Access Compliance Report

Public Rights-of-Way

(Curb Ramps)

Intersection ID: 10470	Main Street: MILTON_RD	Cross Street: PERTH_CT	Location: SE
ADA ID: D9C1F2100969	Ramp Type: PerpDiag	Initial Pass/Fail: Fail	Overall Compliance: No
Severity Score: 22.5			
Codes/Mitigation Info/Possible Solution		Field Measurements/Component Compliance

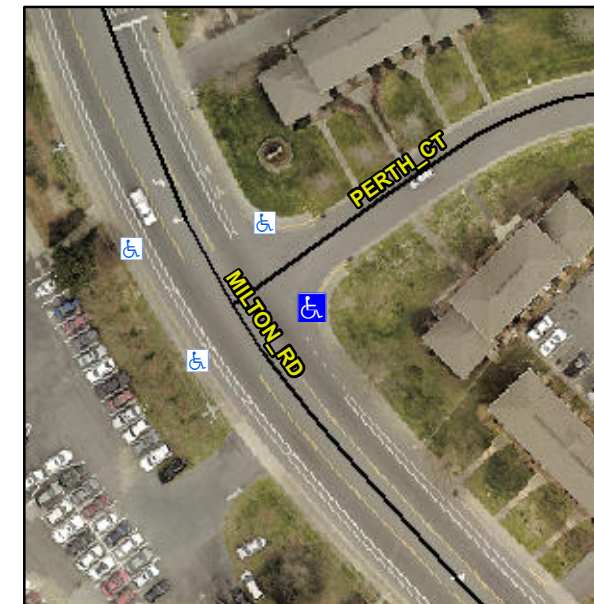
Not Found, R304.5.1, R304.2.2, R304.5.3

Compliance	Description	Data	Compliance	Description	Data
N/A	Ramp Length (in)	59.5	No	Ramp Slope (%)	9.0
No	Ramp Width (in)	37.0	No	Ramp XSlope (%)	2.6
N/A	Flare Type LT	N/A	N/A	Flare Type RT	N/A
N/A	Flare Slope LT (%)	N/A	N/A	Flare Slope RT (%)	N/A
N/A	Flare Traversable LT?	N/A	N/A	Flare Traversable RT?	N/A
N/A	Landing Length (in)	N/A	N/A	DWS Provided?	N/A
N/A	Landing Width (in)	N/A	N/A	DWS Contrast?	N/A
N/A	Landing Slope (%)	N/A	N/A	DWS Length (in)	N/A
N/A	Landing X Slope (%)	N/A	N/A	DWS Full Width?	N/A
N/A	Landing Curb? (Y/N)	N/A	N/A	DWS Offset (in)	N/A
N/A	Shared Landing?	N/A			
N/A	Gutter Ponding?	N/A	N/A	Gutter Slope (%)	N/A
N/A	Gutter Lip Ht (in)	0.5	N/A	Gutter X Slope (%)	N/A
N/A	Painted X Walk1?	No	N/A	Painted X Walk2?	No
	X Walk 1 Direction	To NW		X Walk 2 Direction	To SW
N/A	X Walk 1 Width (in)	N/A	N/A	X Walk 2 Width (in)	N/A
	X Walk 1 Slope (%)	2.3		X Walk 2 Slope (%)	2.9
	X Walk 1 X Slope (%)	0.4		X Walk 2 X Slope (%)	2.7

Remove & Replace Curb Ramp With Two New Directional Ramps or Equivalent.
